15th April 2024

Abi Mark
Senior Environmental Planner, WBOPDC
1484 Cameron Road
Greerton, Tauranga 3112
Via email: abi.mark@westernbay.govt.nz

Response to Submissions, Further Mitigation Plan Change 95 – Pencarrow Estate Pongakawa

Pencarrow Estate Pongakawa - Zoning

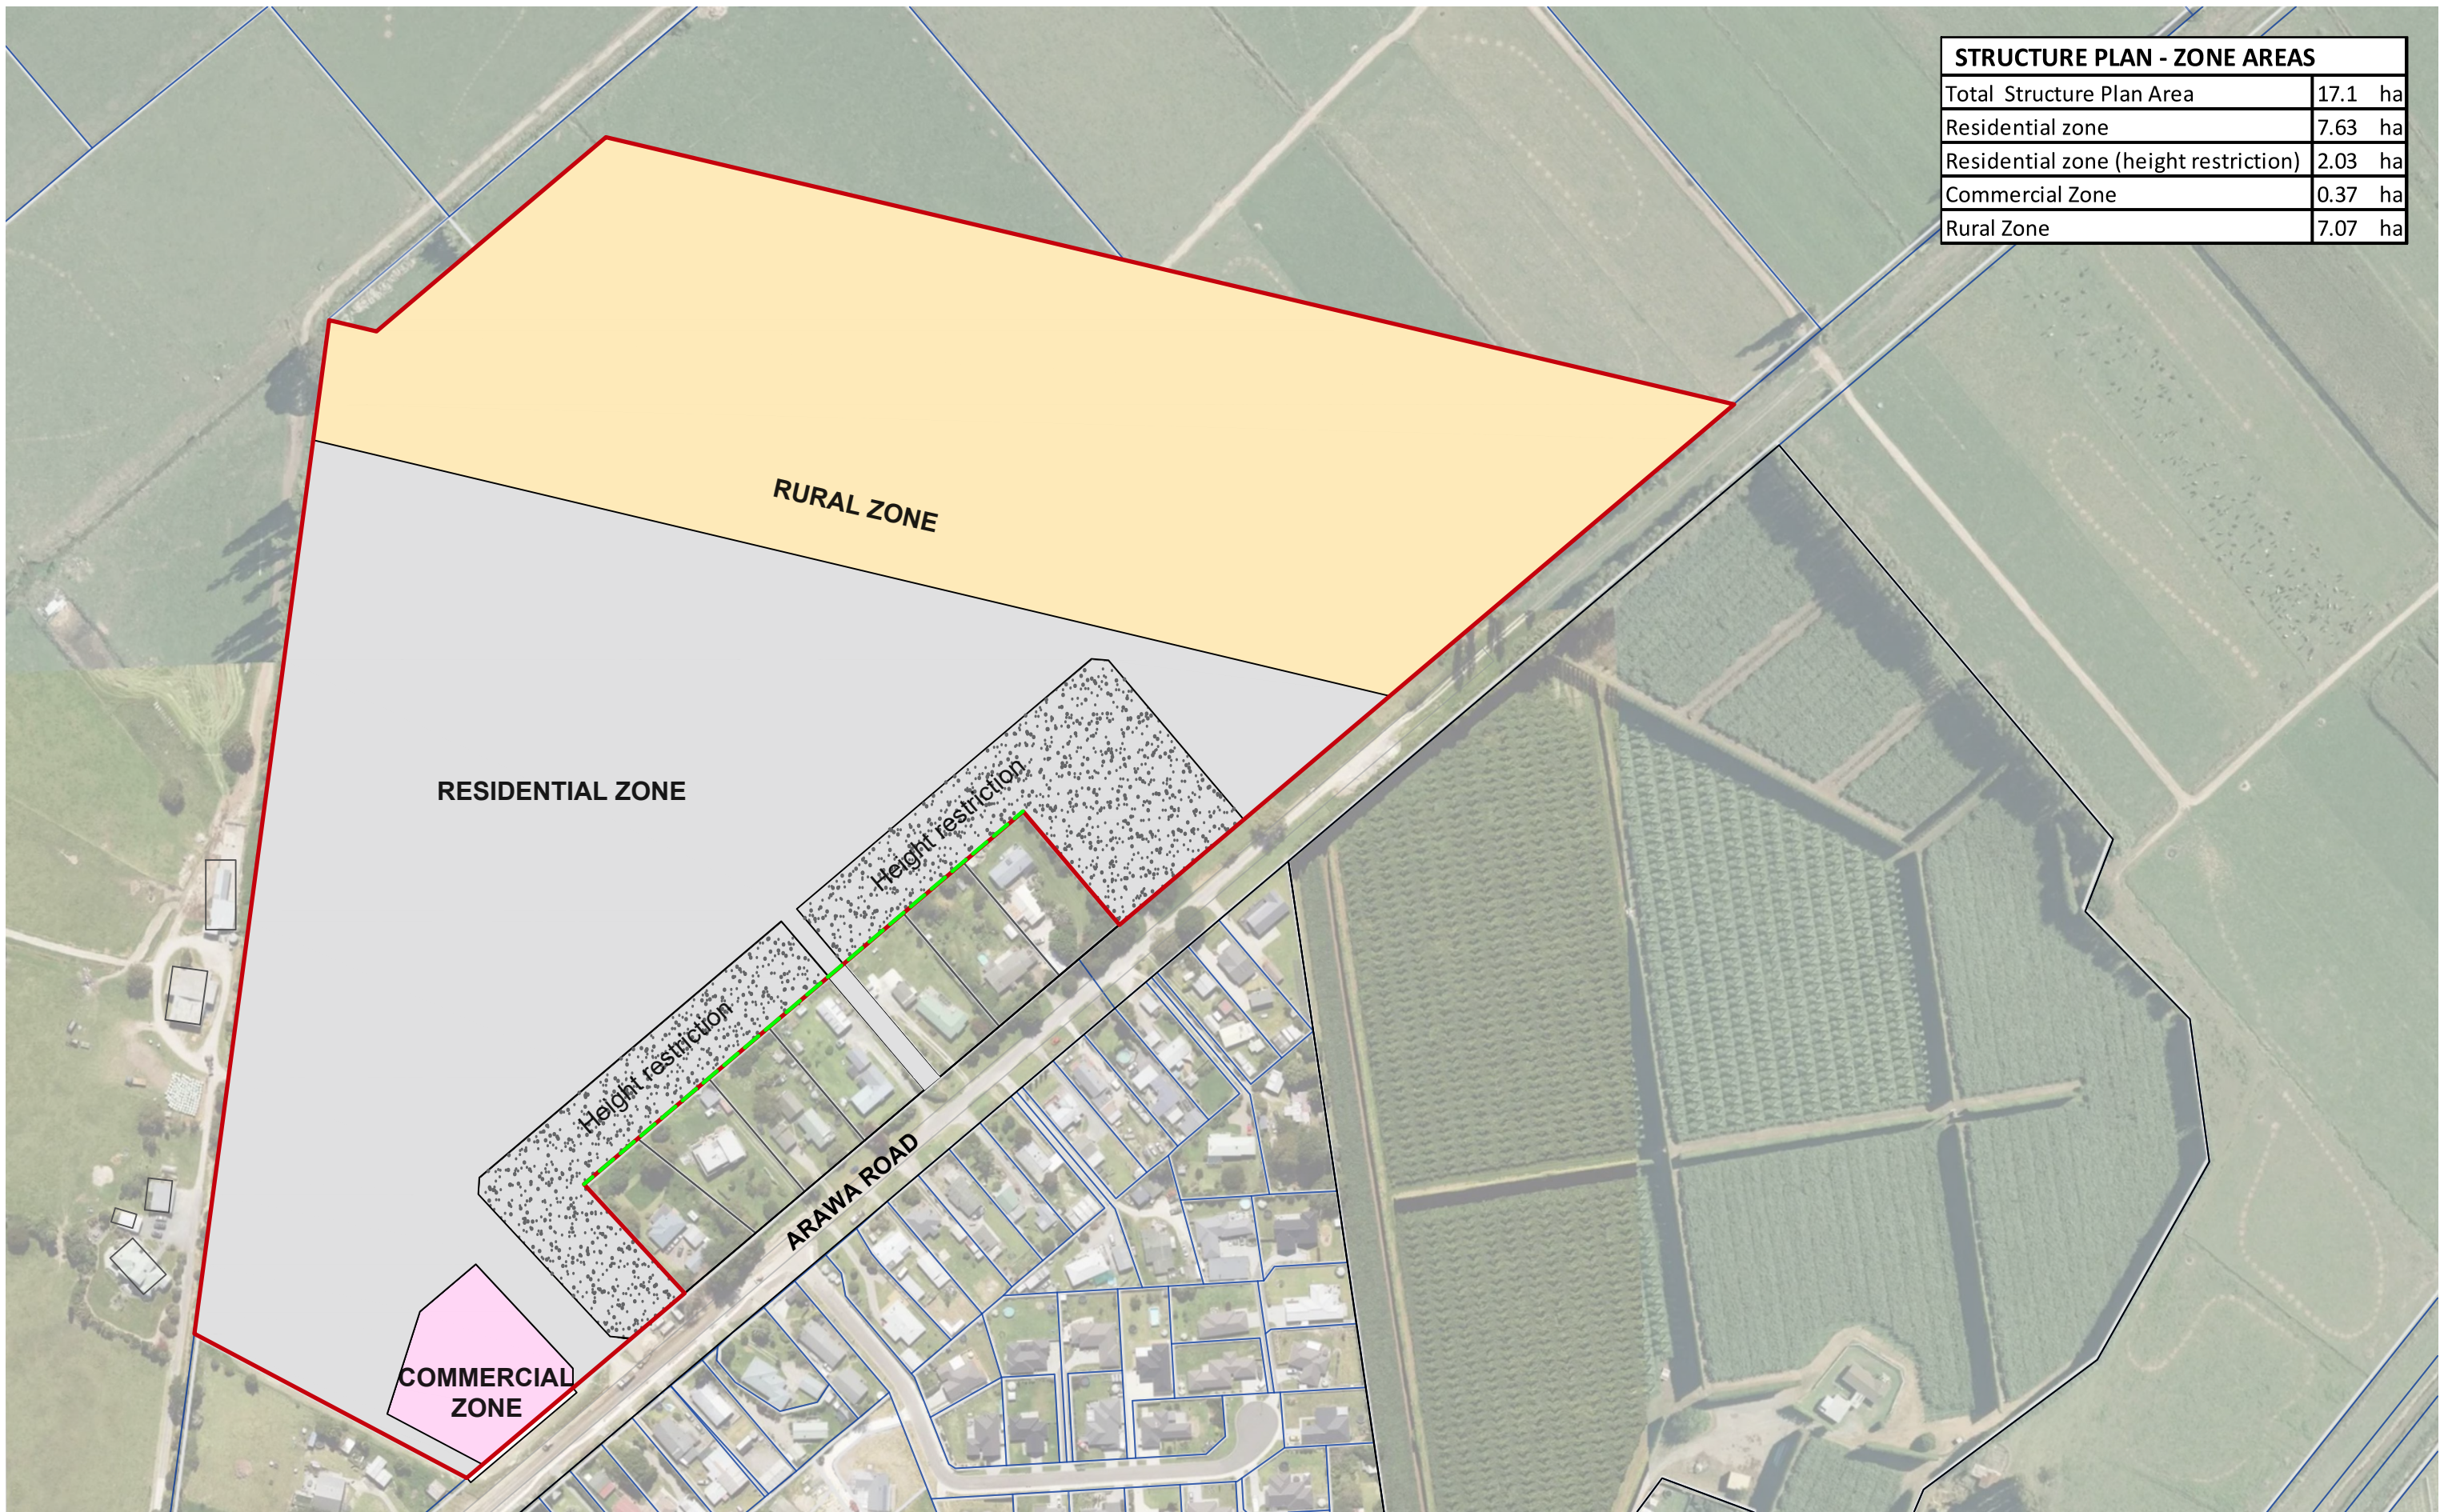
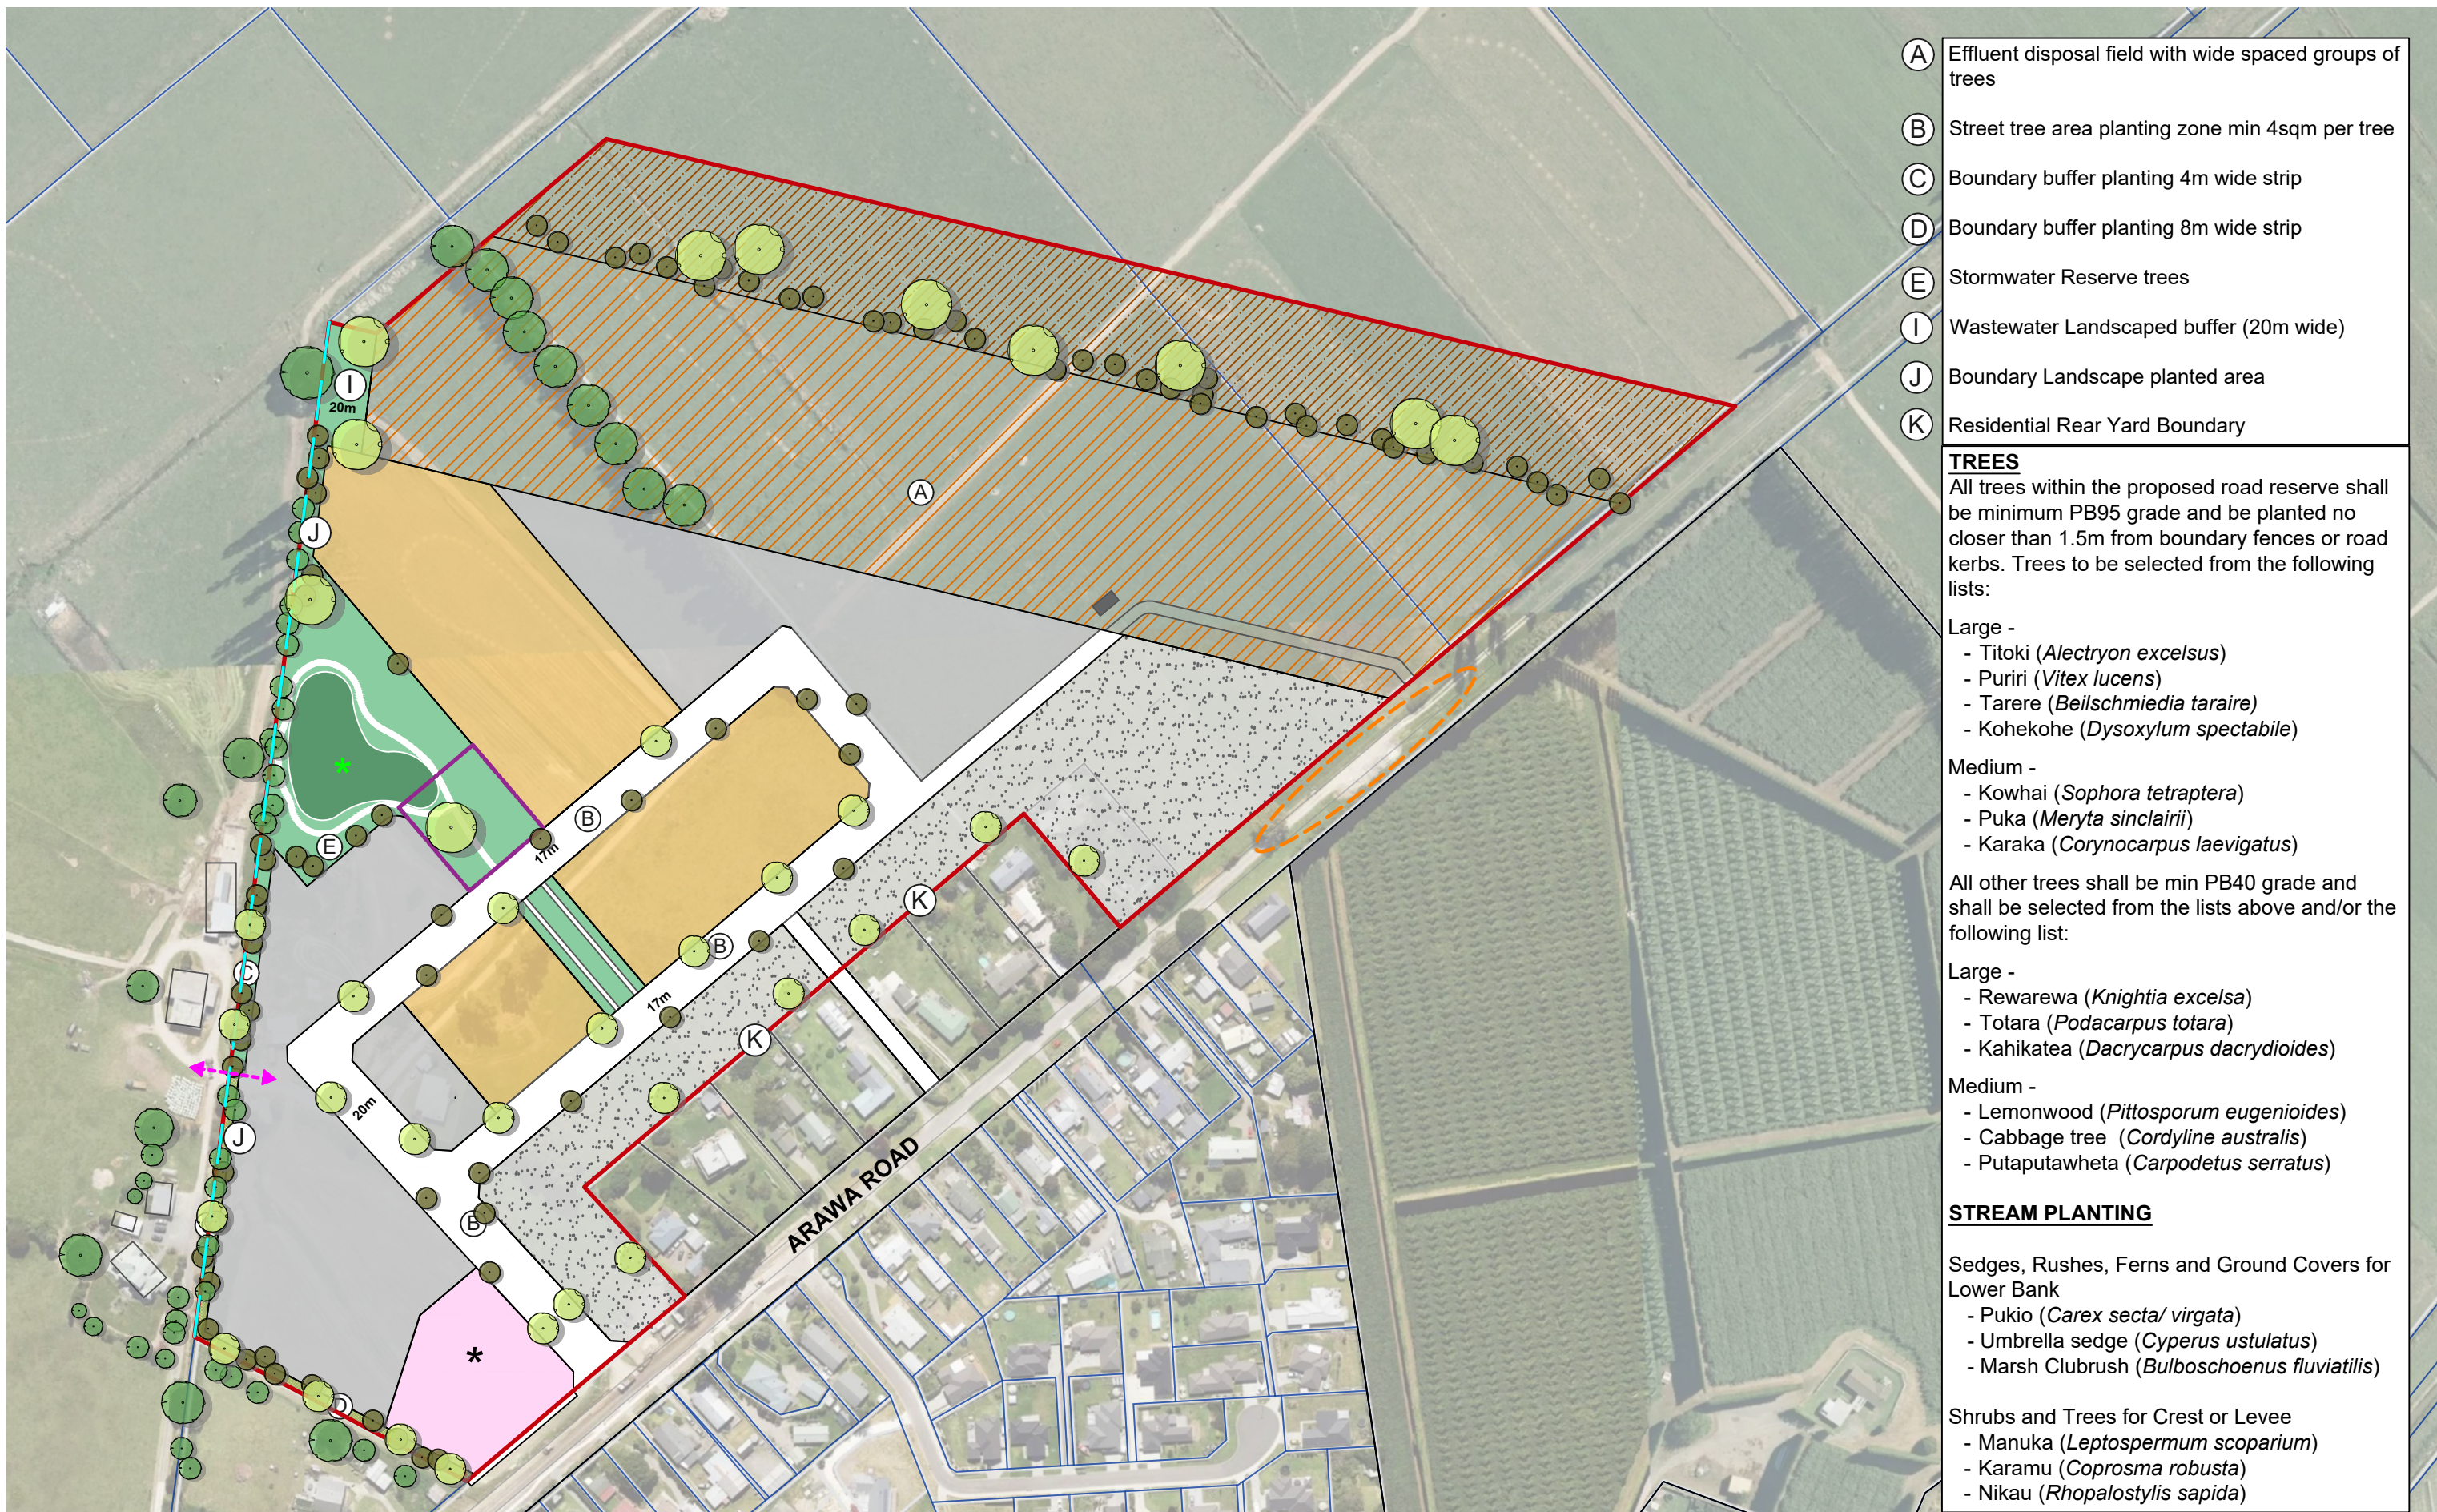
Numerous submissions discuss the general loss of rural character and amenity that accompanies urbanisation. This change is acknowledged, particularly in respect of Rural-zone properties on Arawa Road abutting the plan change site to the south-east. Adverse effects attached to this change have been sought to be reduced, by way of restricting the height and siting of future built form adjacent to eastern boundary of the site. Future building height adjacent to the eastern boundary is restricted to one storey.

Initially a set-back of 5m was applied to the eastern boundary of the plan change site, in combination with the height restriction. This being derived from considering the range of setback distances/boundary-constructed buildings along the rear boundary of Arawa Road properties. Noting concerns about outlook and spatial separation to future built form that have been raised in submissions, this setback has been increased to 8m. Trees have also been specified in this setback for greater natural elements within outlook towards the plan change area. This is reflected in revised proposed wording of rules to apply within Chapter 13 of the District Plan, see **Appendix B**, and revised structure plan drawings at **Appendix C**.
